Subject: Dresden Station Units 2 & 3  
Quad-Cities Station Units 1 & 2  
Proposed Amendment to Facility  
Operating License Nos. DPR-19,  
DPR-25, DPR-29 and DPR-30 Associated  
with Reanalysis of the Loss-of-  
Coolant Accident  
NRC Docket Nos. 50-237/249/254/265

Pursuant to 10 CFR 50.59, Commonwealth Edison proposes to amend the Dresden Station Units 2, 3 and Quad-Cities Station Units 1, 2 Technical Specifications regarding revised Maximum Average Planar Linear Heat Generation Rate (MAPLHGR) limits associated with reanalysis of the Loss-of-Coolant Accident. Reference (a) transmitted the General Electric Report NEDO-24046, dated August 1977, entitled "Loss-of-Coolant Accident Analysis Report for Dresden Units 2, 3 and Quad-Cities Units 1, 2 Nuclear Power Stations (Lead Plant)." NEDO-24046 documents the completion of the ECCS reevaluation and forms the basis for the revised MAPLHGR limits.

FIGURE 3.5.1.B

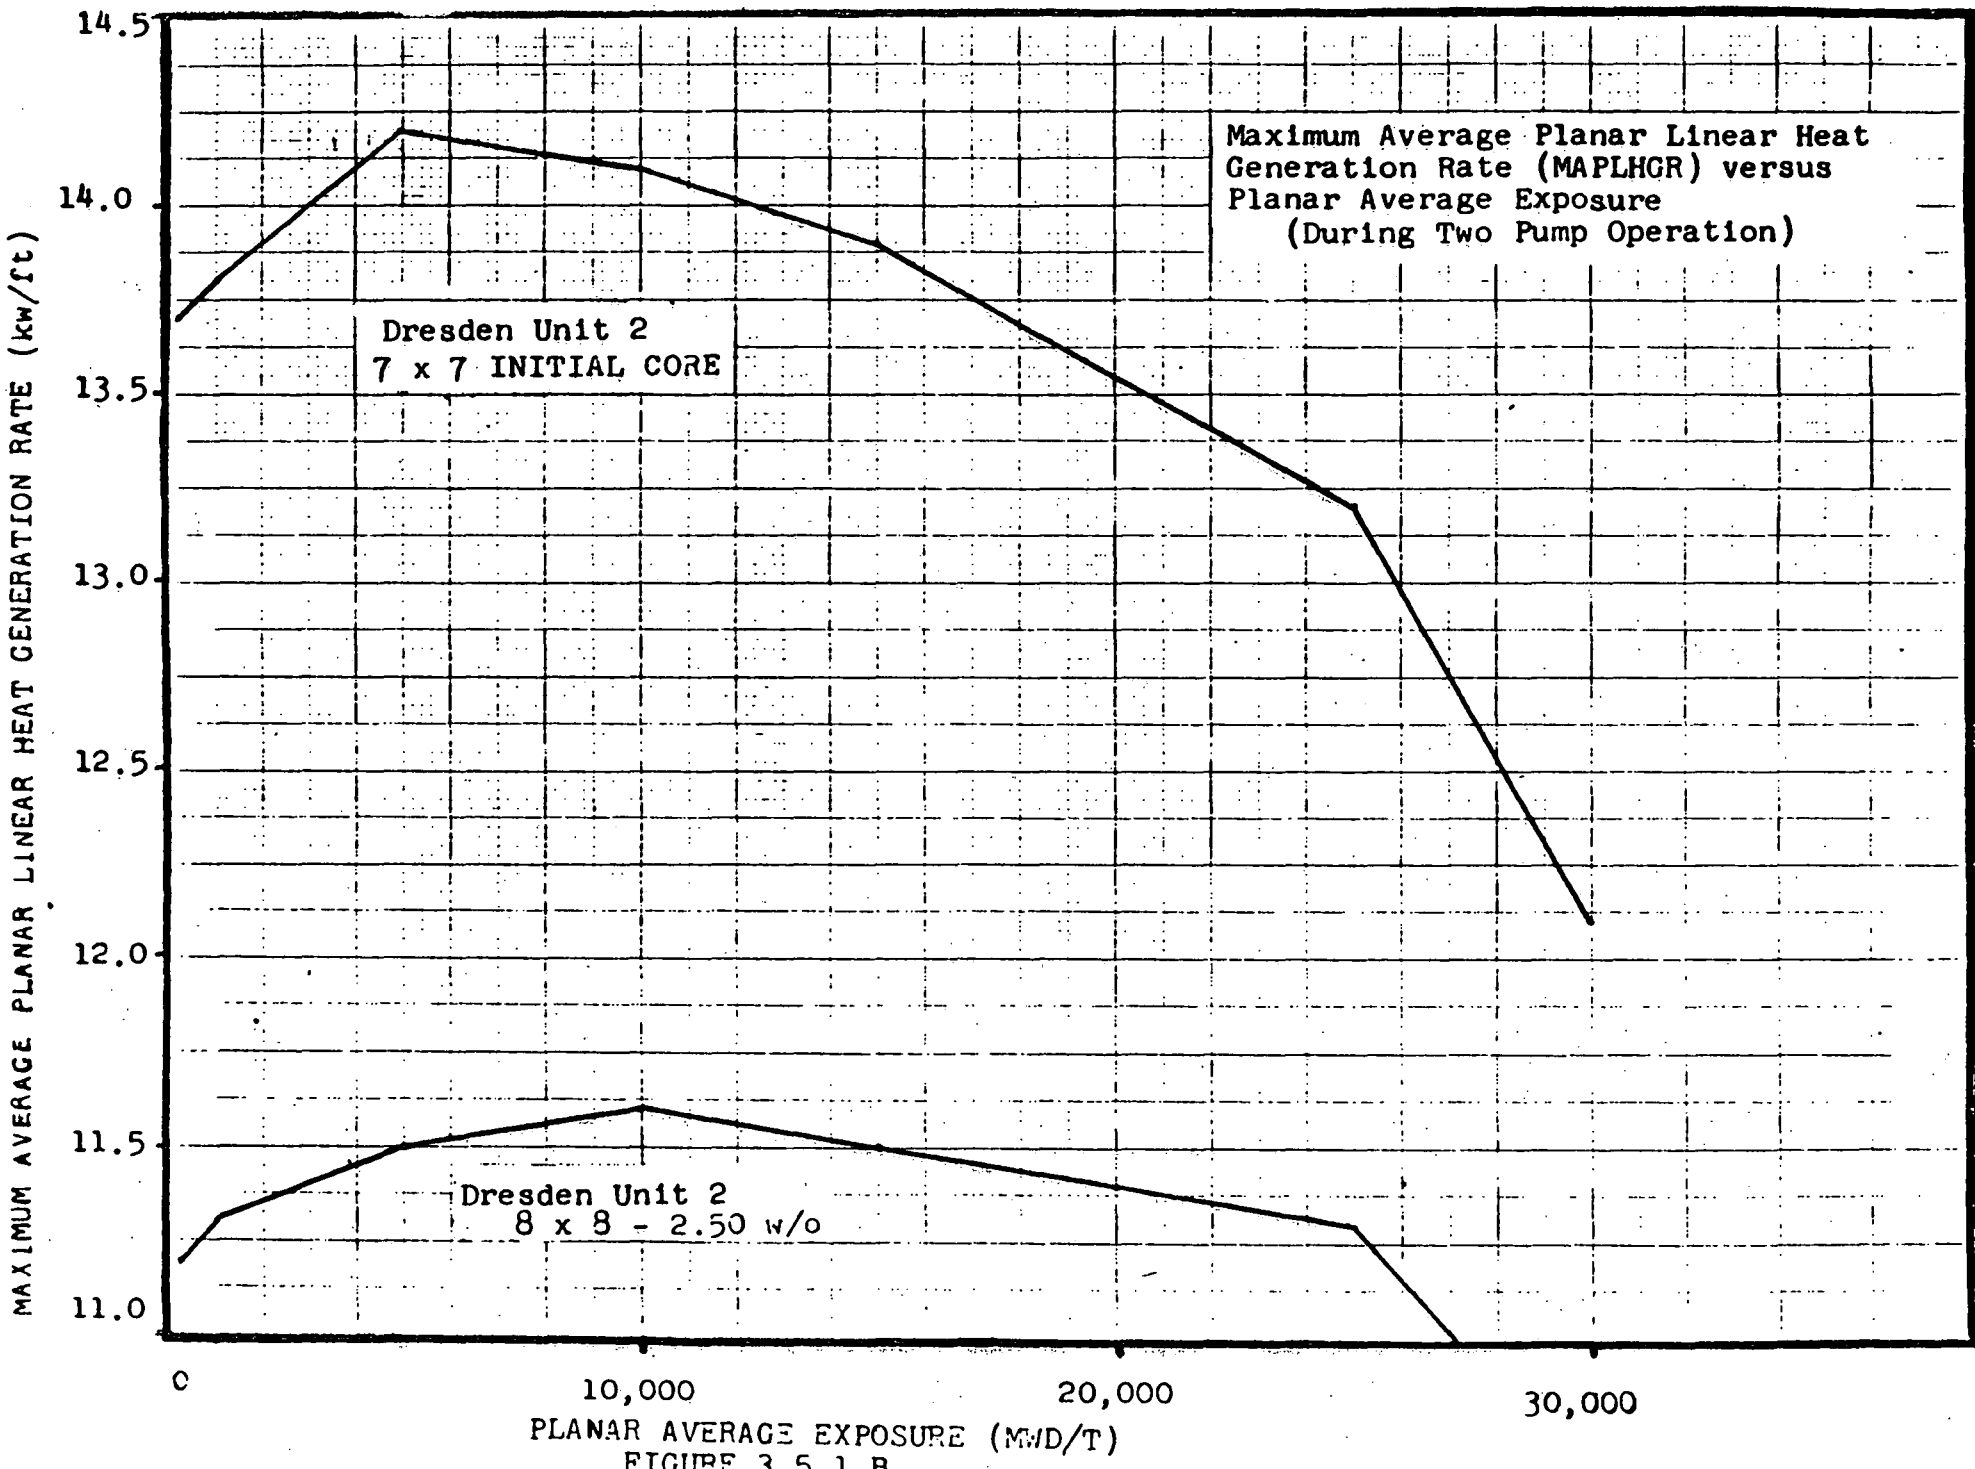
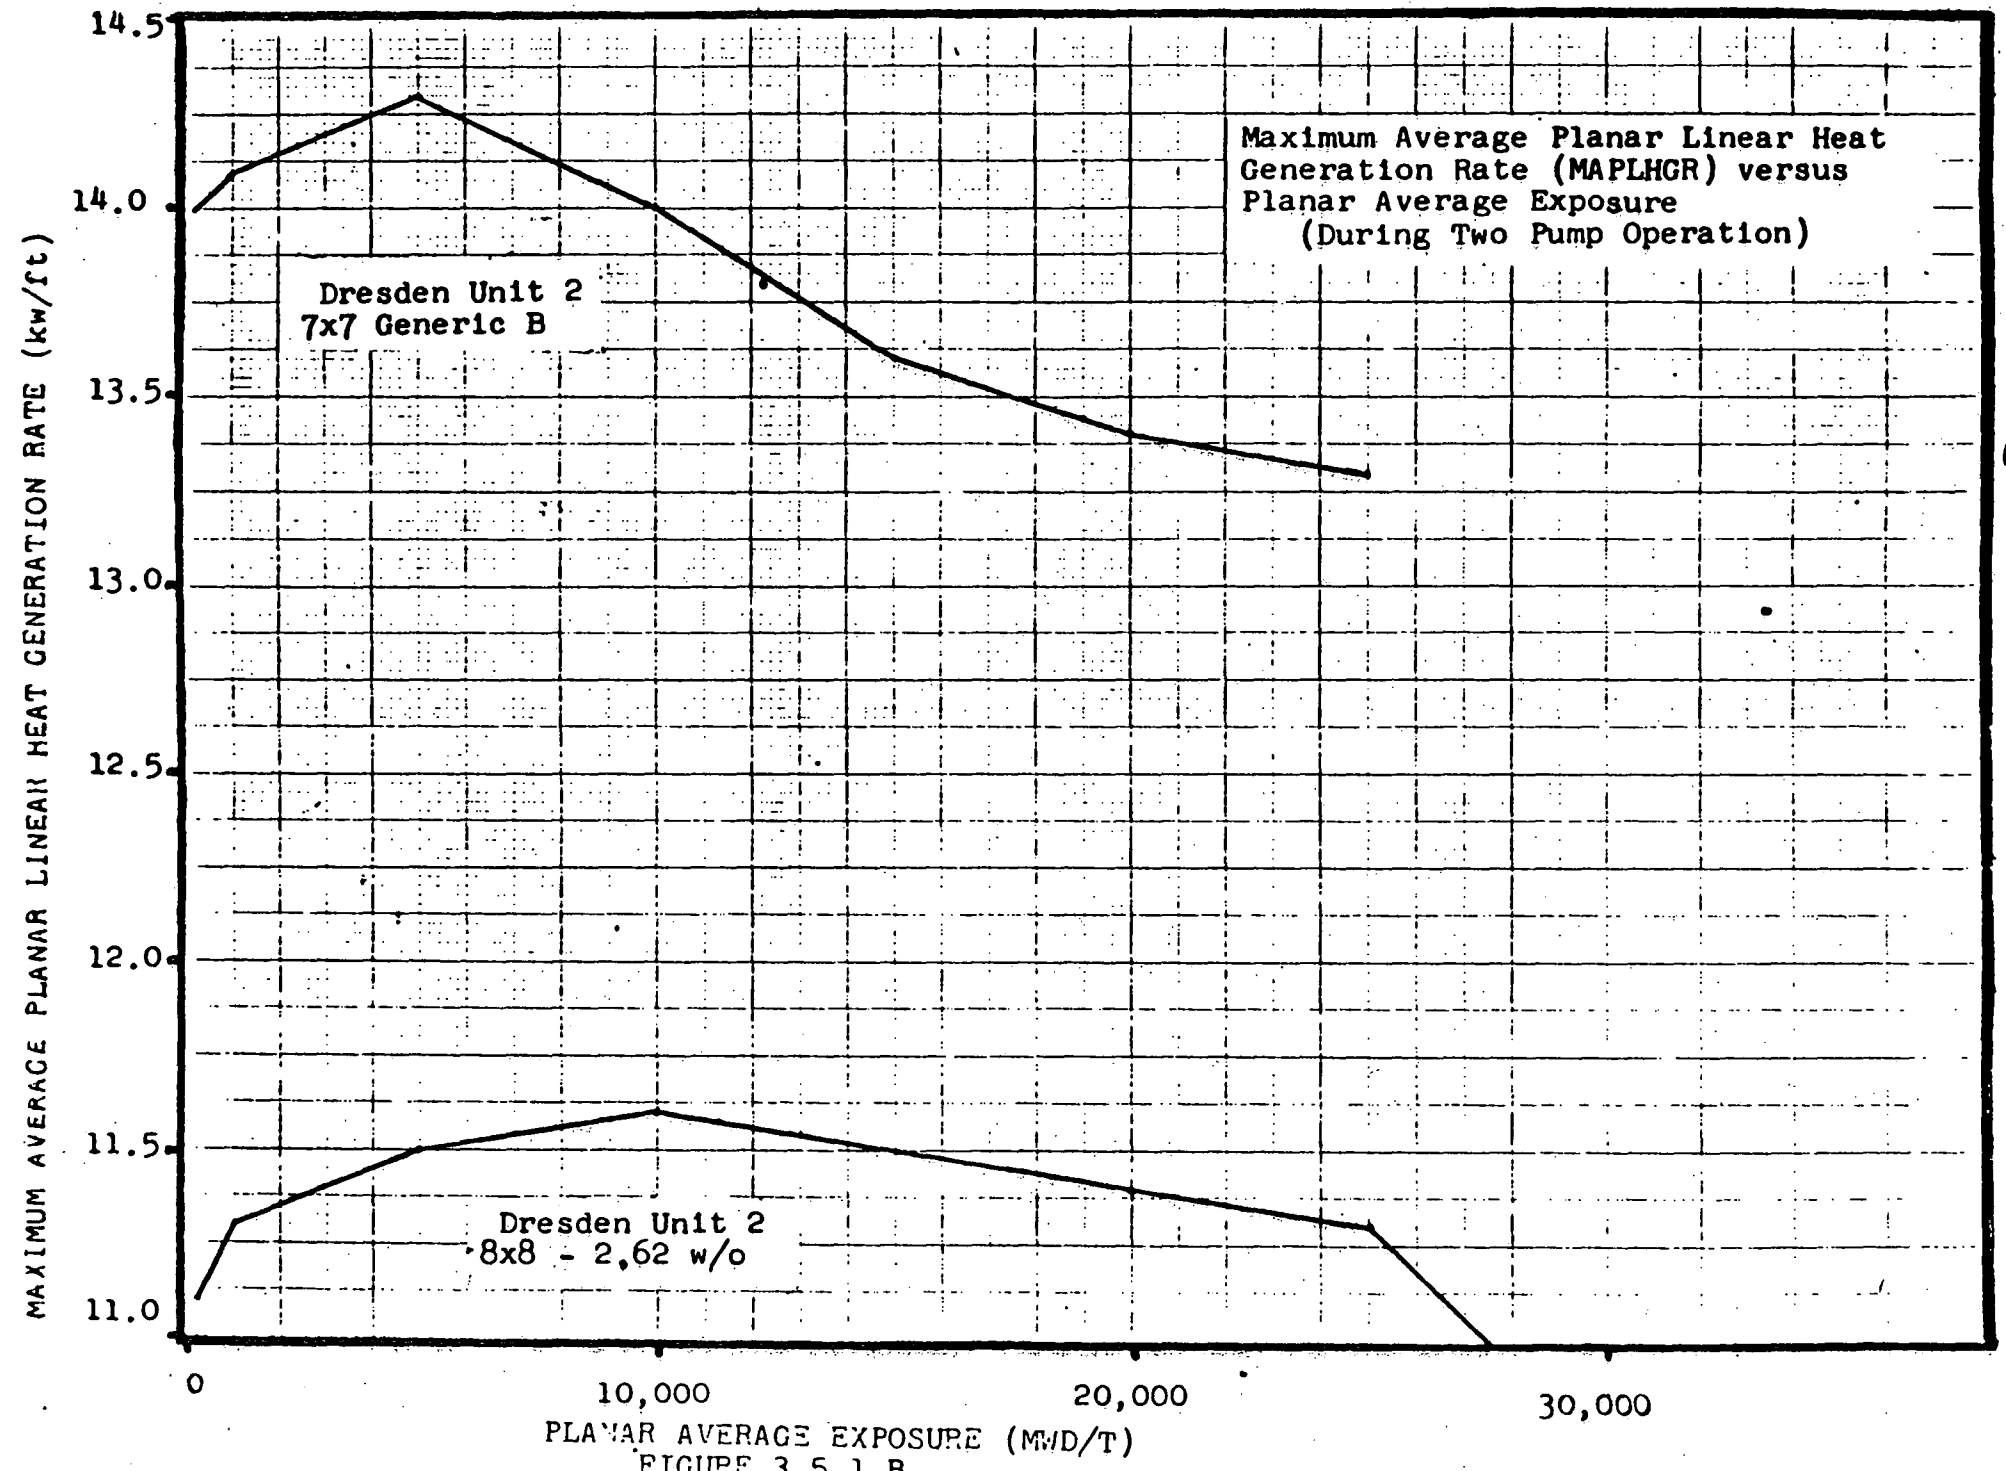
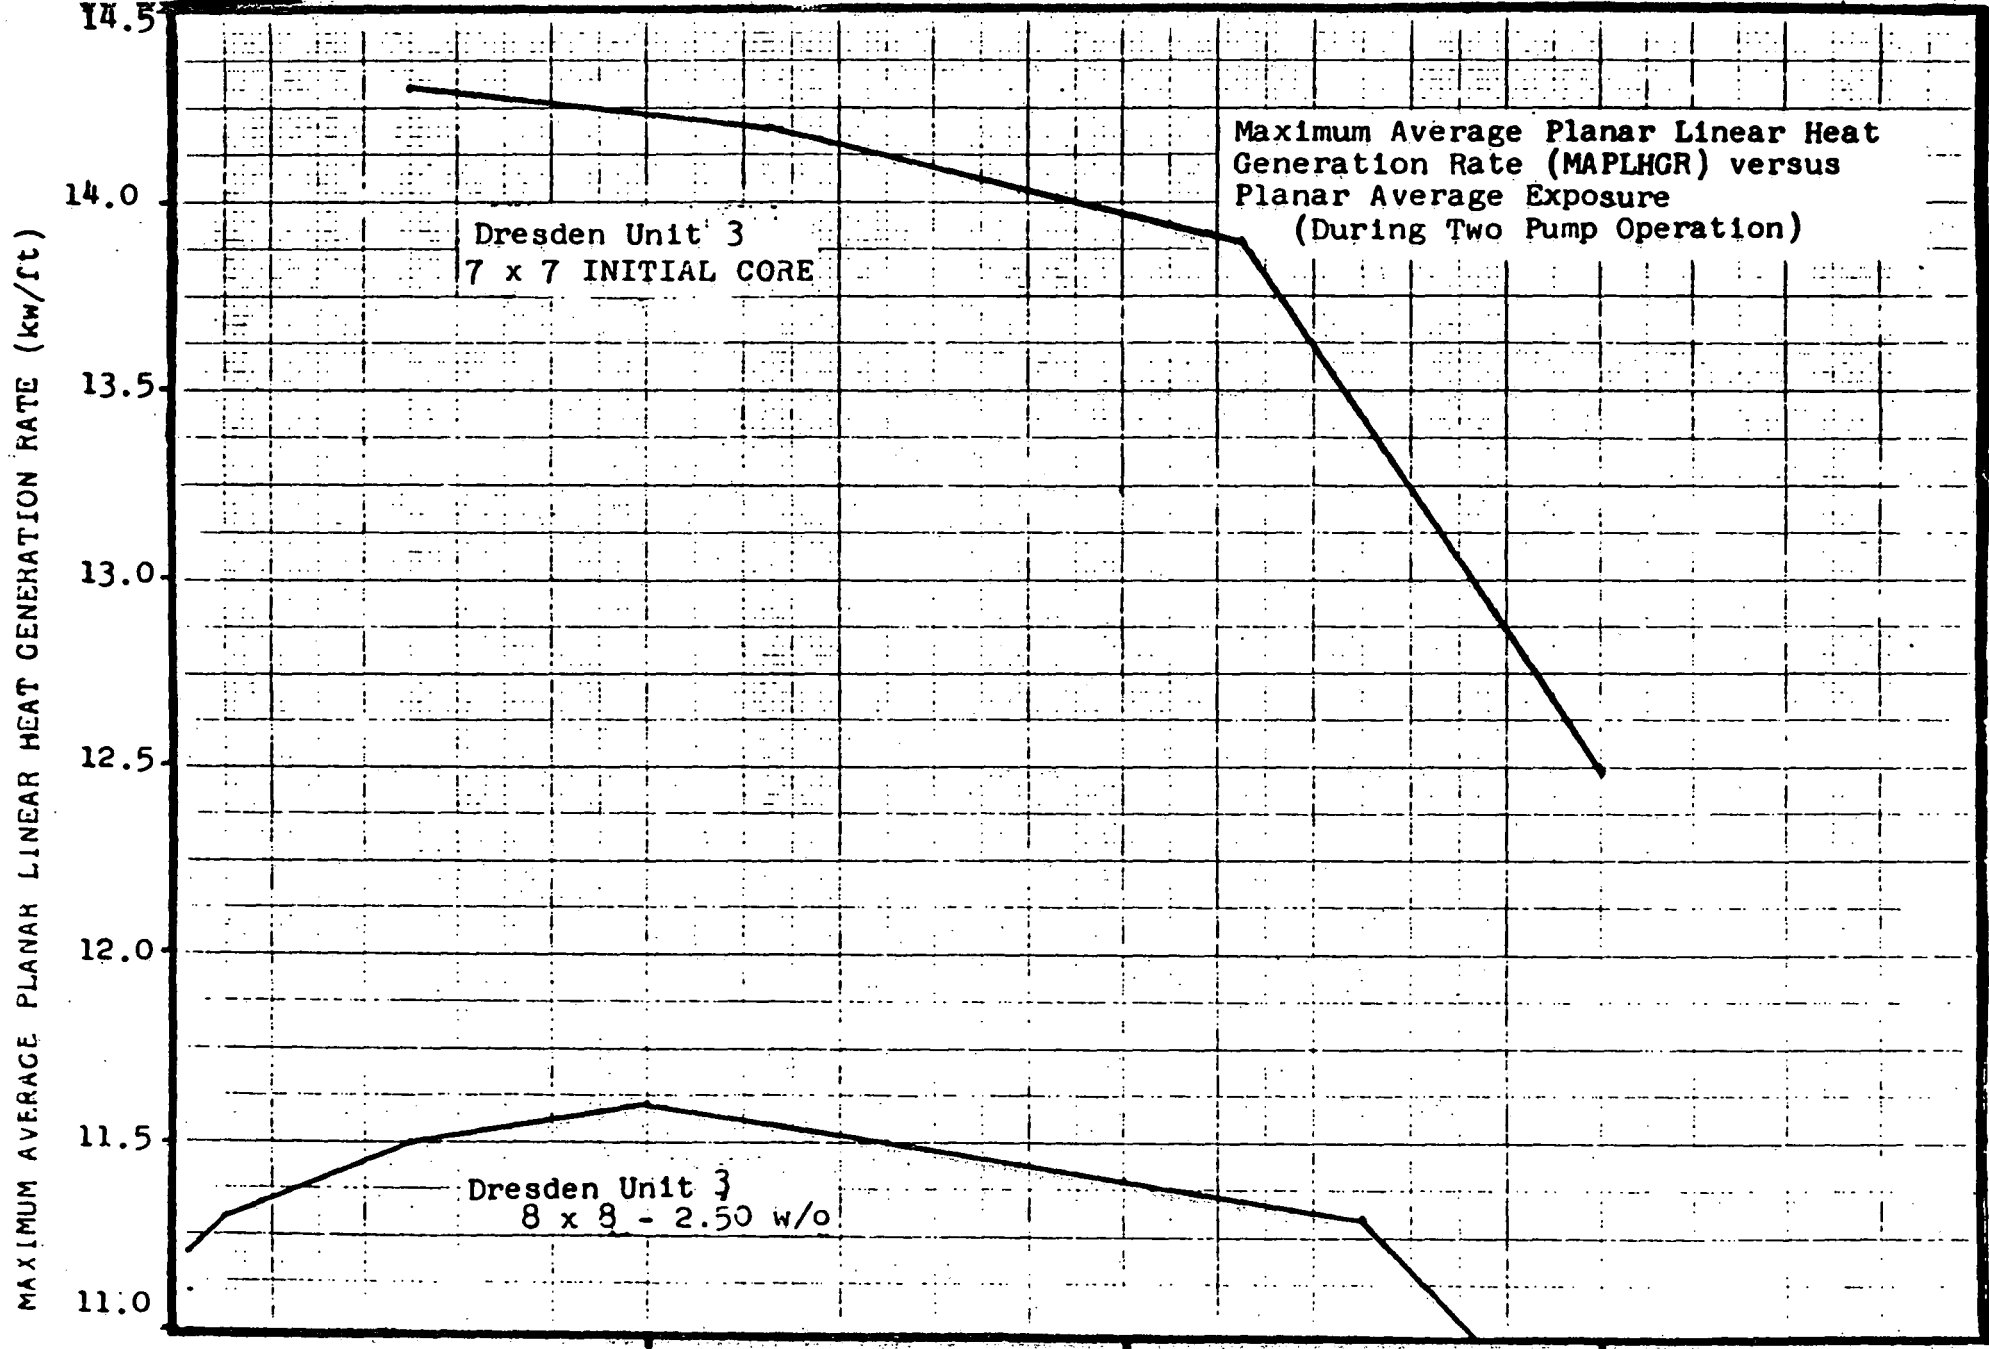
On December 15, 1976, Commonwealth Edison derated Dresden 2, 3 and Quad-Cities 1, 2 limits (MAPLHGR) by 4% to eliminate the double credit for structural absorption. In January 1977, General Electric estimated the net effect of input errors to be a 6.5% decrease in MAPLHGRs. Commonwealth Edison implemented the estimated reduction, on an interim basis, pending a final ECCS reevaluation.

Report NEDO-24046 documents the completion of the required ECCS reevaluation. The analysis was performed using recent NRC approved model changes in the General Electric computer codes. These changes remove unnecessary conservatism and tend to counter the effects of the input errors.

The maximum average planar LHGRs shown in Figure 3.5.1 are based on calculations employing the models described in Reference (1). Power operation with LHGRs at or below those shown in Fig. 3.5.1 assures that the peak cladding temperature following a postulated loss-of-coolant accident will not exceed the 2200°F limit. Those values represent limits for operation to ensure conformance with 10CFR50 and Appendix K only if they are more limiting than other design parameters.

The maximum average planar LHGRs plotted in Fig. 3.5.1 at higher exposures result in a calculated peak clad temperature of less than 2200°F. However the maximum average planar LHGRs are shown on Fig. 3.5.1 as limits because conformance calculations have not been performed to justify operation at LHGRs in excess of those shown.
